**From:** Bachman, Melanie  
**Sent:** Tuesday, January 17, 2017 8:33 AM  
**To:** Cunliffe, Fred; Fontaine, Lisa; Mulcahy, Carriann; Mathews, Lisa A  
**Subject:** FW: Petition No. 1247, Phases II and III

Subject: Petition No. 1247, Phases II and III

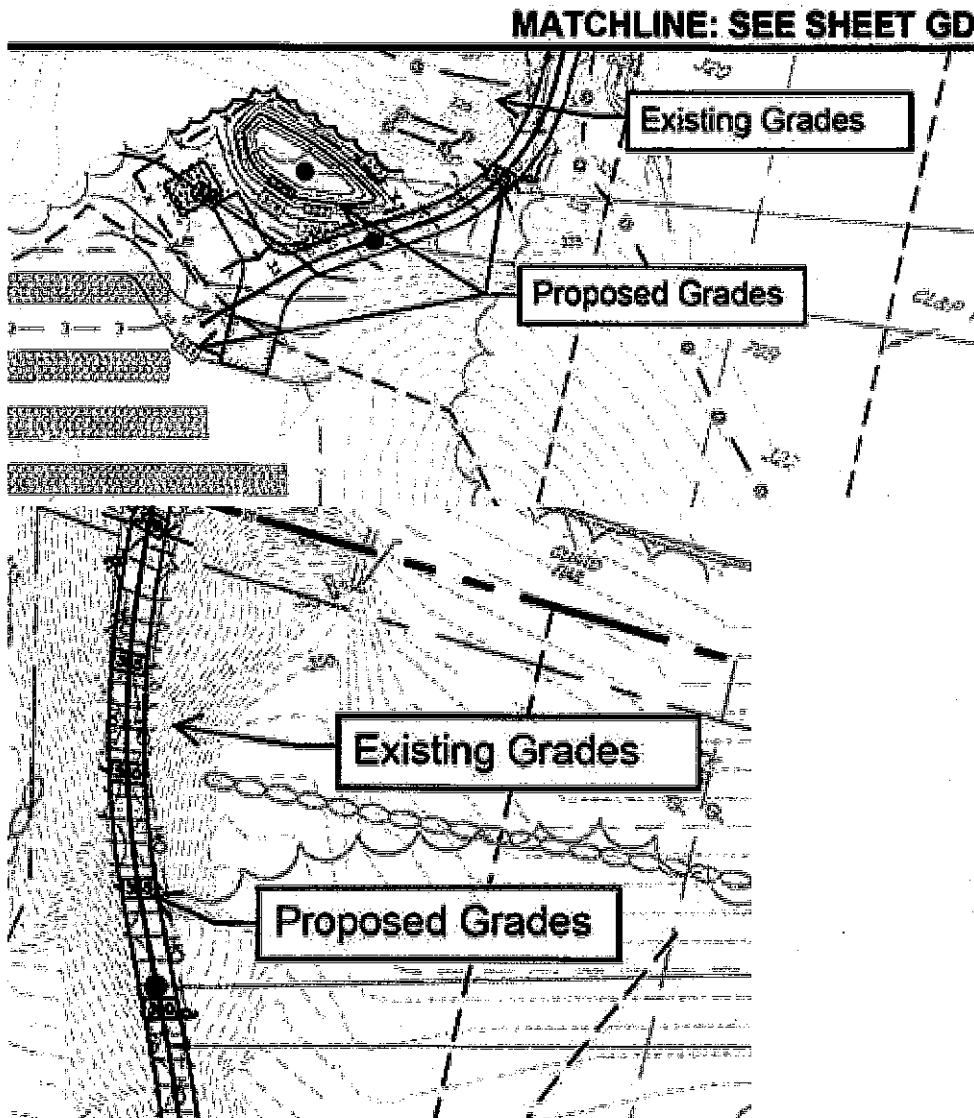
In the Phase III plans, sheet PRO-1 shows the access drive profile. However, nowhere in the Phase II or Phase III is any proposed grading provided. Based on what I am seeing on the Access Drive Profile sheet (PRO-1), there are some cut areas along the driveway as it gets closer to the solar field location. None of the grading is

shown on the plans. Only topography I see are existing grades which represent both pre and post construction activities. Is this something the company can confirm? Proposed grading for the access driveway and the stormwater basin are shown on GD-2 and GD-3 of the plans. The proposed contours are labeled with "boxes" at 5' intervals and additionally at stormwater basin and end of grading to make sure proposed contours were clear. Do to the limited work along the access driveway the proposed grades mimic the existing pretty closely so the contours do not extend outside the edge of driveway much. At the end of the driveway there is more of a cut which is shown with the last contour being elevation 333. Below are two blow ups of the GD plans to help provide clarification, GD-2 on the left and GD-3 on the right.
